**RE: ADDITIONAL INFORMATION RESPONSE – 10 WILLIAM STREET, FAIRLIGHT**

Council have sent a request for additional information with regard to a development application for alterations and additions to the dwelling. The letter raised issues with regard to a geotechnical report and the proposed outdoor fireplace.

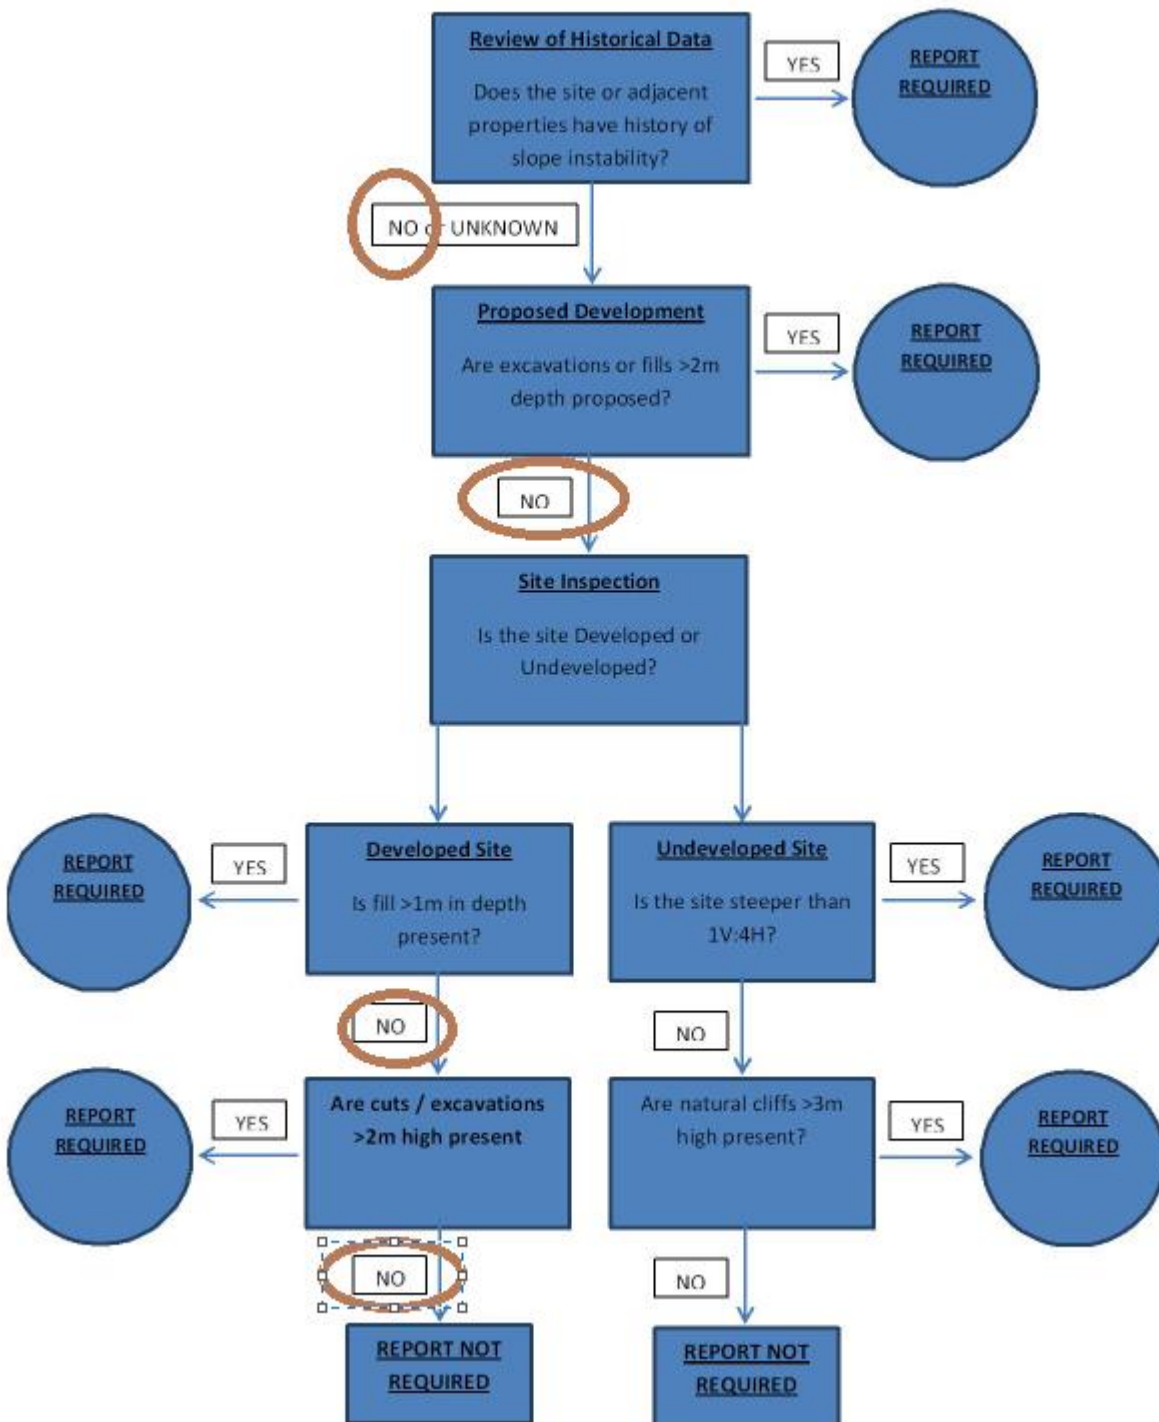
While the plans show that no excavation or fill is required and that the site is not significantly sloping Council is still unclear as to whether a geotechnical report is required. The flow chart checklist, which is provided in schedule 11 of the DCP, is provided below.

No geotechnical report is required.

## Flue Heights & Flue Termination

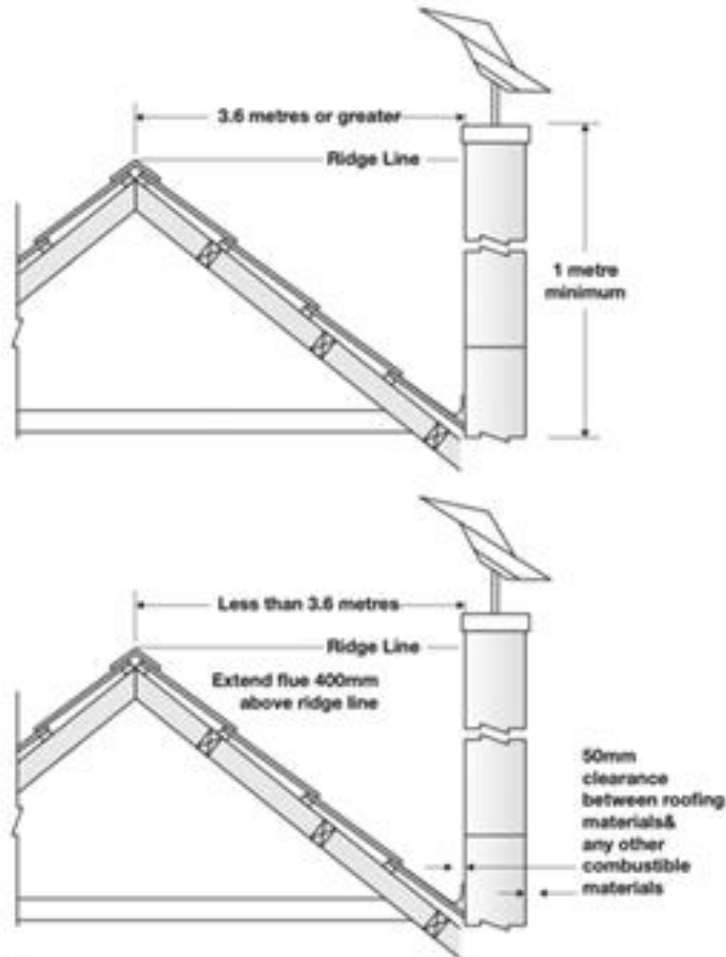
## 2. Solid Fuel Heaters

**Description:** Jetmaster BBQ built into 3.0m high brick chimney with flue extension to meet guidelines.

10 William street ridge line 52.76

12 William Street upstairs windows sill 51.07 Head 52.12 with gutter height 52.15

The proposal seeks to build a 3m brick structure to house the fireplace with the flue extension to the ridge line height of RL 52.76. The drawings below provide more details.
